<p>نگهداشت و افزایش تولید میدان نفتی بینک سطح الارض</p> <p>احداث ردیف تراکم گاز در ایستگاه جمع آوری بینک</p>																									
<p>شماره پیمان: ۰۵۳ - ۰۷۳ - ۹۱۸۴</p>

<table><tr> <th colspan="8">HAZOP REPORT FOR COMPRESSOR STATION</th> </tr><tr> <td>D00</td> <td>0004</td> <td>RT</td> <td>GE</td> <td>120</td> <td>PEDCO</td> <td>GCS</td> <td>BK</td> </tr></table>

The purpose of this document is to provide the results of “HAZOP Study” for **Binak Oilfield Development – Surface Facilities; New Gas Compressor Station**.

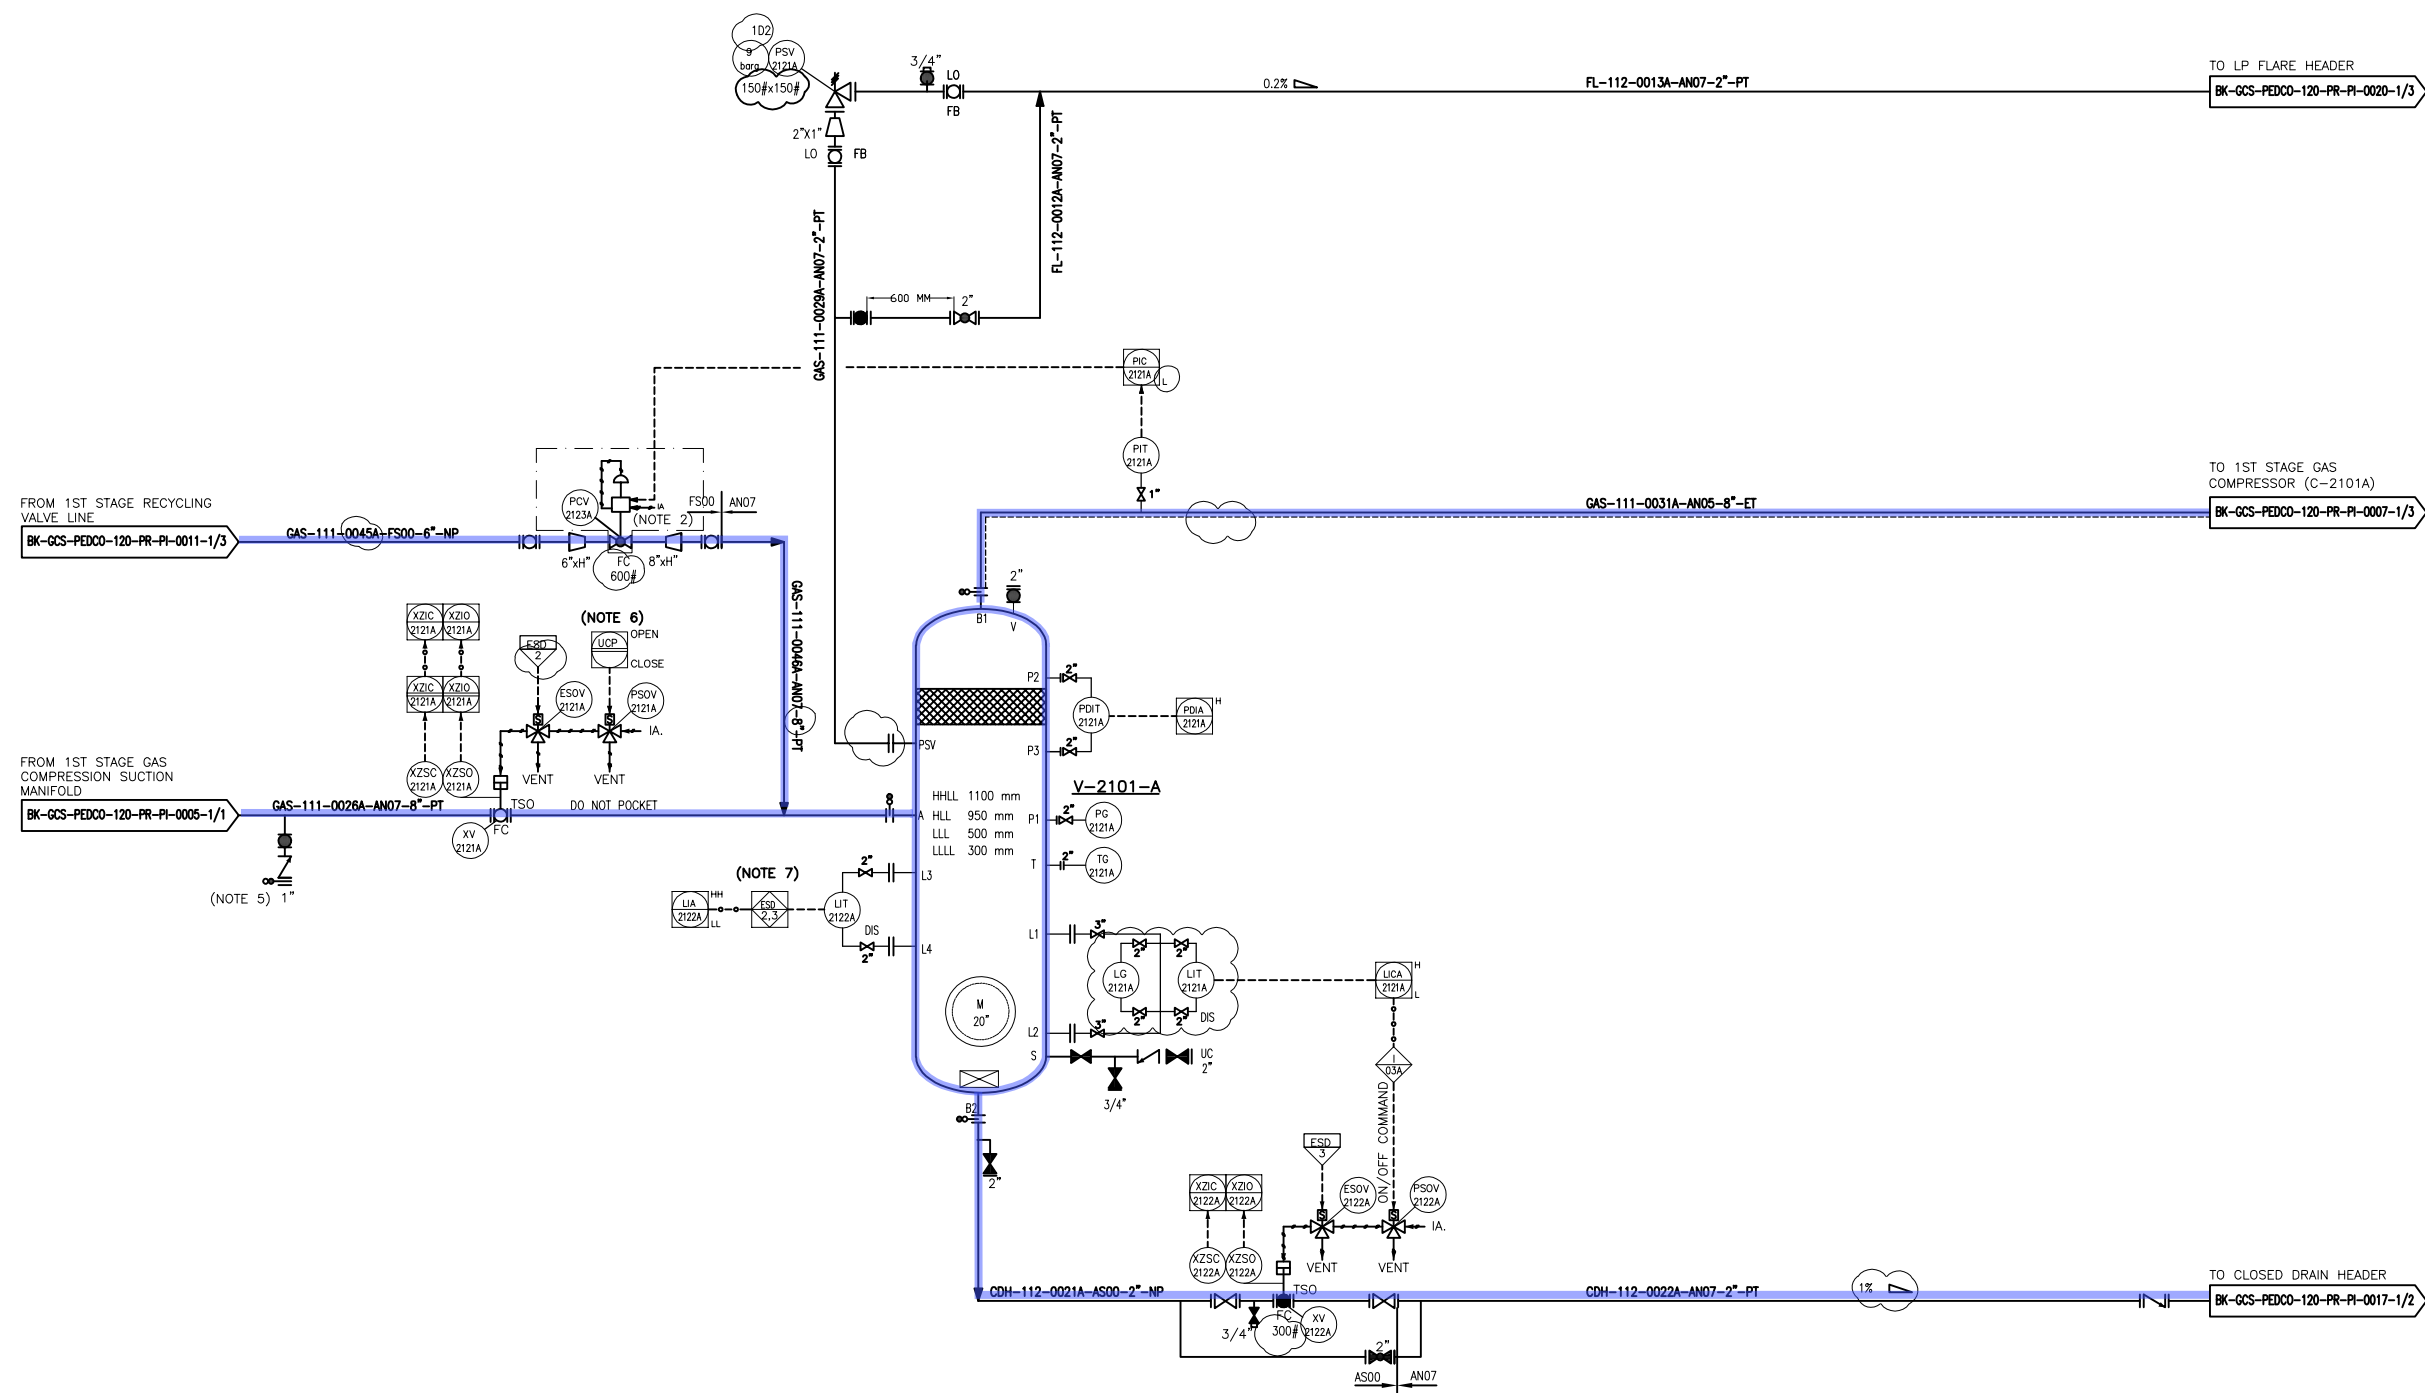
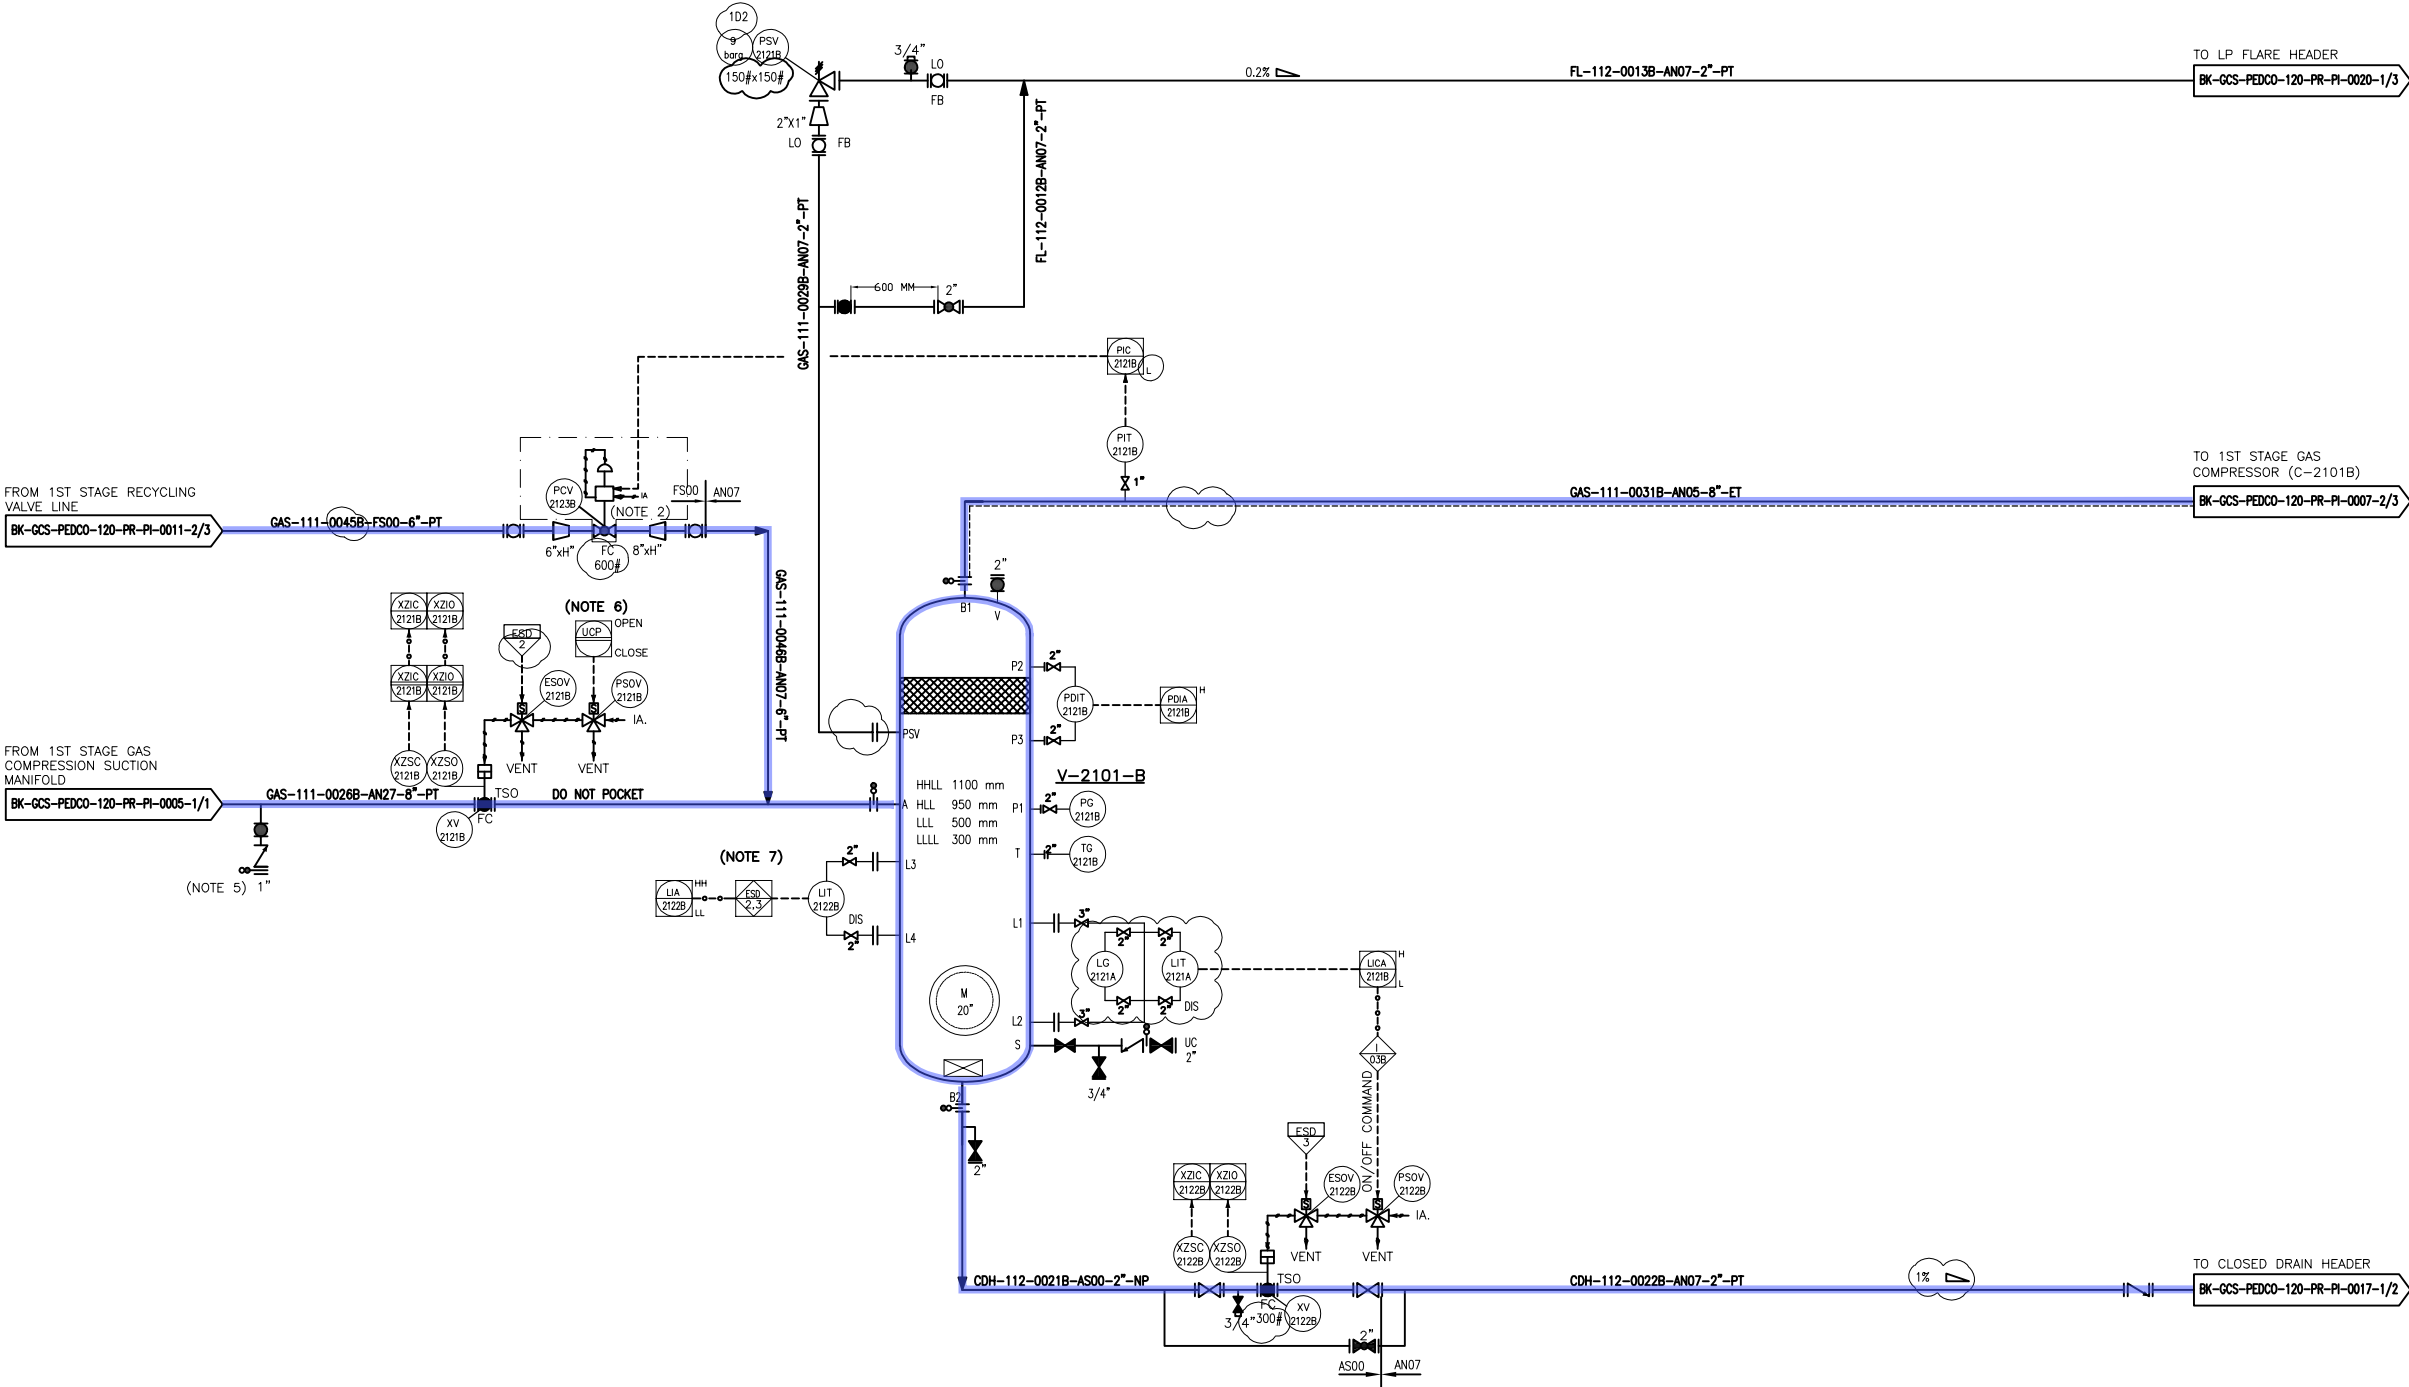
40. Consider maintenance lock for fan of air coolers in data sheet.	Consequences: 5.10.1.1	Contractor	Closed
41. Consider drain connection on low point of line between V-2101A and compressor.	Consequences: 5.11.1.1	Contractor	Closed
